# Access Compliance Report

## Public Rights-of-Way

Intersection ID: 9519	Main Street: FAIRFIELD_ST	Cross Street: OAKLAWN_AV	Location: SE
ADA ID: ACEAEEBDC28A	Ramp Type: Perp	Initial Pass/Fail: Fail	Overall Compliance: No
Severity Score: 13.75			
Codes/Mitigation Info/Possible Solution		Field Measurements/Component Compliance

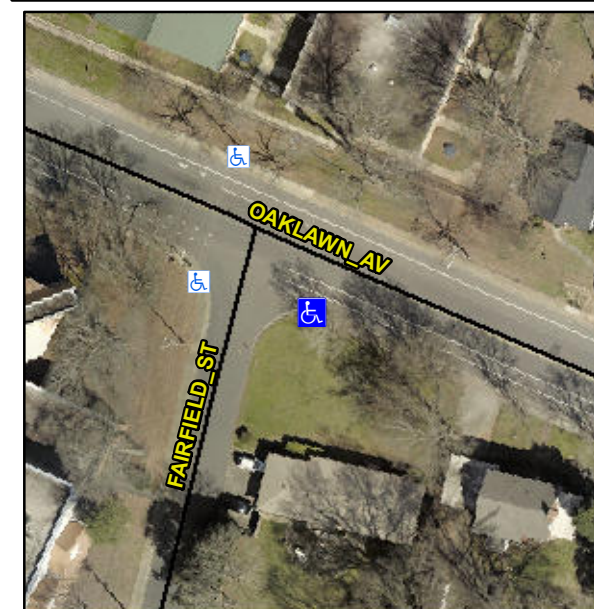
**Not Found, R304.2.2, R304.5.3**

Compliance	Description	Data	Compliance	Description	Data
N/A	Ramp Length (in)	29.0	No	Ramp Slope (%)	8.8
Yes	Ramp Width (in)	60.0	No	Ramp XSlope (%)	4.7
N/A	Flare Type LT	N/A	N/A	Flare Type RT	N/A
N/A	Flare Slope LT (%)	N/A	N/A	Flare Slope RT (%)	N/A
N/A	Flare Traversable LT?	N/A	N/A	Flare Traversable RT?	N/A
N/A	Landing Length (in)	N/A	N/A	DWS Provided?	N/A
N/A	Landing Width (in)	N/A	N/A	DWS Contrast?	N/A
N/A	Landing Slope (%)	N/A	N/A	DWS Length (in)	N/A
N/A	Landing X Slope (%)	N/A	N/A	DWS Full Width?	N/A
N/A	Landing Curb? (Y/N)	N/A	N/A	DWS Offset (in)	N/A
N/A	Shared Landing?	N/A			
N/A	Gutter Ponding?	N/A	N/A	Gutter Slope (%)	N/A
N/A	Gutter Lip Ht (in)	N/A	N/A	Gutter X Slope (%)	N/A
N/A	Painted X Walk1?	No	N/A	Painted X Walk2?	N/A
	X Walk 1 Direction	To NW		X Walk 2 Direction	N/A
N/A	X Walk 1 Width (in)	N/A	N/A	X Walk 2 Width (in)	N/A
	X Walk 1 Slope (%)	2.0		X Walk 2 Slope (%)	N/A
	X Walk 1 X Slope (%)	0.5		X Walk 2 X Slope (%)	N/A

**Remove & Replace Entire Ramp.**
